PRODUCT ADVISORY

Corrections to Standard Microcircuit Drawing 5962-95729 for Intersil Product HCS154*

Refer to: PA10091

Date: September 21, 2010

FIGURE 3. Logic diagram.

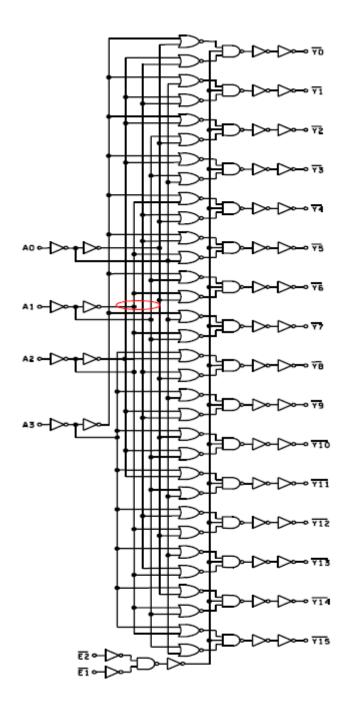
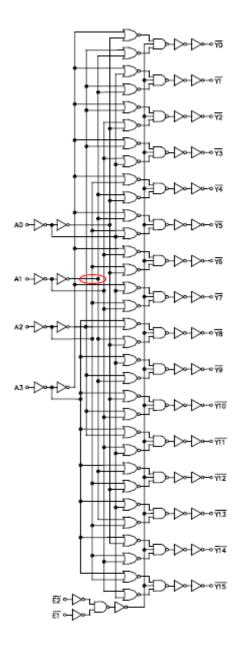
This advisory is to inform you that Intersil has made corrections to DSCC (Defense Supply Center Columbus) SMD (Standard Microcircuit Drawing) 5962-95729 for the HCS154* products. The updates correct errors in the Truth Table (Inputs A0 – A3 were reversed) and Logic Diagram (Input A1 connection). There have been no changes of any type to the screening or product itself. The updates to the DSCC SMD are complete. The released SMD is available on the DSCC website at http://www.dscc.dla.mil/downloads/milspec/smd/95729.pdf.

Incorrect Logic Diagram – PA10091

Correct Logic Diagram - PA10091
